PLAT COMMITTEE

November 4, 2024 @ 4:00 p.m.

BLOOMINGTON PLAN COMMISSION
STAFF REPORT
Location: 1217 N. Madison Street

CASE #: DP-37-24 / PLAT2024-09-0038
DATE: November 4, 2024

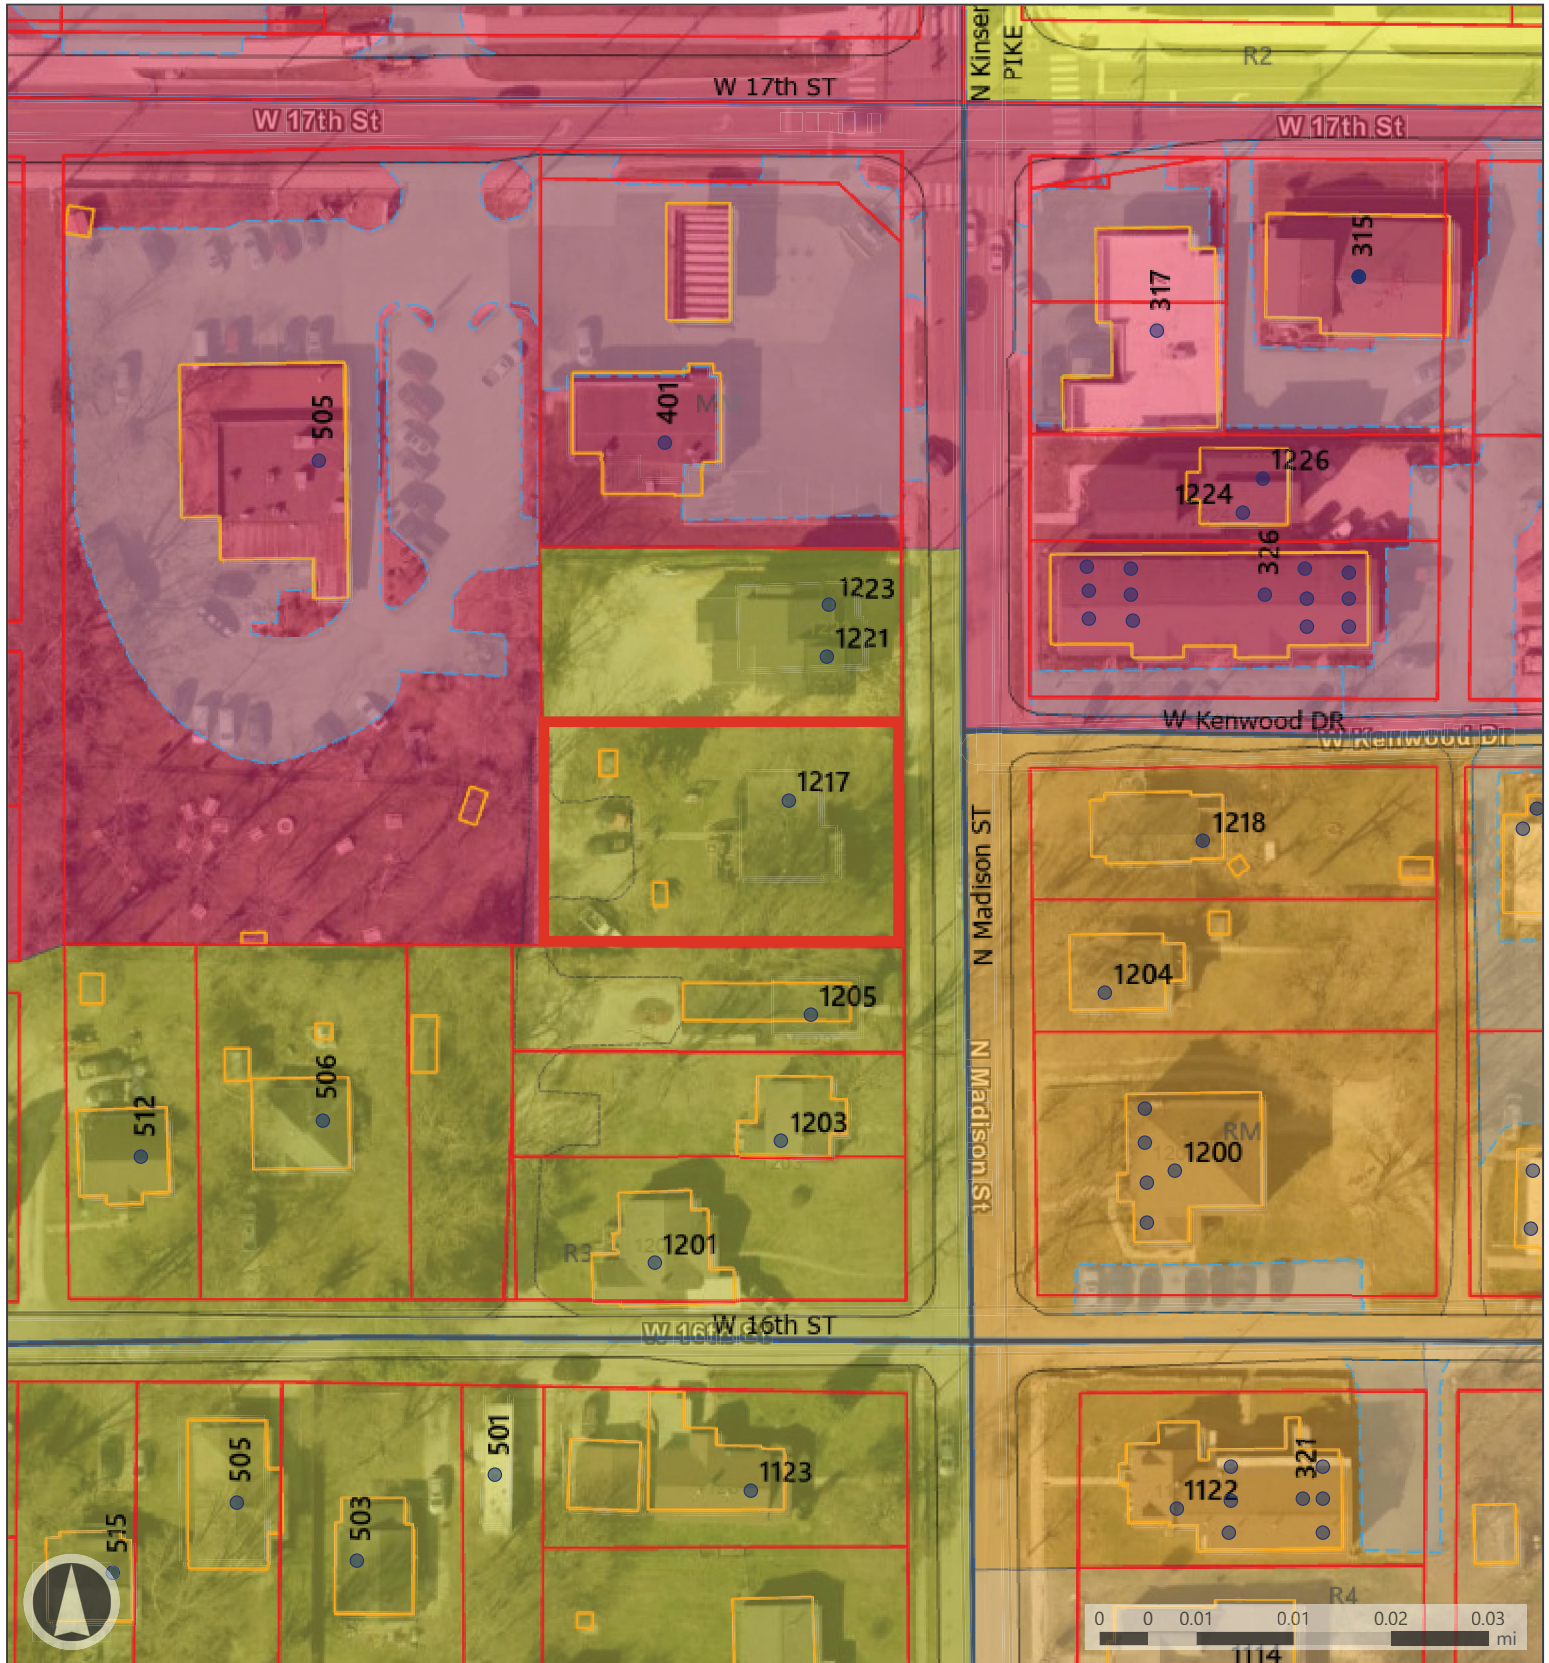
Transportation facilities: Madison Street is classified as a General Urban typology and requires a 10' wide concrete sidewalk and 8' tree plot. A total of 84' of right-of-way is required based on the Transportation Plan. The Planning and Transportation Director has approved the preservation of the existing sidewalk and tree plot. There are existing street trees in the tree plot, however one additional tree is required along this frontage to meet UDO requirements are met. A condition of approval has been included to that effect.

Tree plot width: The minimum tree plot width required for the General Urban typology is 8' and the petitioner is proposing to maintain the existing 5' wide tree plot. The City recently installed street trees along this section of Madison Street and are in good condition. The Planning and Transportation Director has approved the preservation of the existing sidewalk and tree plot due to the adjacent slope challenges with relocating the sidewalk further into the property. Street trees are required not more than 30' from center and one additional tree is needed to meet the UDO requirements.

ROW width: Madison Street should have a total of 84' of right-of-way. The petitioner will be dedicating approximately 15' of right-of-way along this frontage to meet the total 42' of right-of-way required from centerline.

1. Individual drainage plans will be submitted to CBU for approval with the building permits for each lot.
2. Each lot must be constructed to the either the Sustainable Development or Affordable Housing Incentives through a Zoning Commitment.
3. Street trees are required not more than 30' from center along the entire property frontage.
4. All easements on the plat must be defined per UDO requirements.

Street Tree Planting Plan Detail
Proposed and Existing Trees for Lot 2

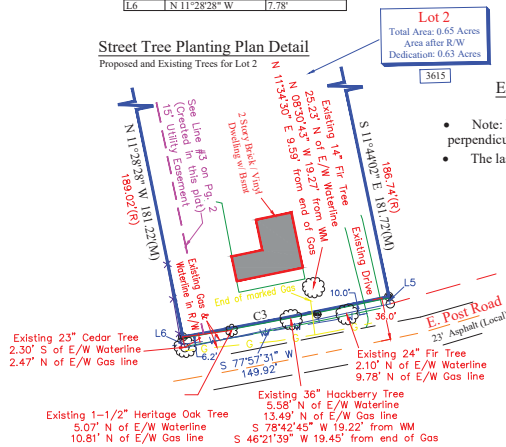
- A street tree planting plan is provided on sheet 2 of the secondary plat. Several existing large trees are less than the minimum 10-foot separation from public water lines, but are all at least five feet from water lines. The Planning and Transportation Department has approved these planting locations as an authorized alternative per section 20.04.080(c)(4) of the Unified Development Ordinance (UDO).

adjacent to the street when there is not room within the public right-of-way. The planting plan included with the plat shows two large street trees along the Post Road frontage of lot 1, and five large street trees along the Post Road frontage of lot 2. For lot 1, both street trees are marked as existing because they were planted on October 29, 2024. The trees deviate from UDO planting standards for species (Heritage Oak *Quercus x macdanielii* is not included in the UDO list of permitted street tree species because it is a hybrid with the non-native English Oak *Quercus robur*), size (1-½"-caliper where the standard is 2"-caliper), and location (9.17', 7.19', and 5.05' from public water lines where the minimum is 10'). For lot 2, four of the street trees have existed on the site for many years, although they deviate from UDO planting standards for species (Cedar and Fir are not included in the UDO list of permitted street tree species) and location (2.30', 5.58', and 2.10' from the public water line and 2.47' and 9.78' from the public gas line where the minimum is 10'). The fifth street tree for lot 2 is marked as existing because it was planted on October 29, 2024. This tree deviates from UDO planting standards for species (Heritage Oak *Quercus x macdanielii*), size (1-½"-caliper where the standard is 2"-caliper), and location (5.07' from the public water line where the minimum is 10'). The Planning and Transportation Department has approved these tree plantings as an authorized alternative per section 20.04.080(c)(4) of the Unified Development Ordinance (UDO).
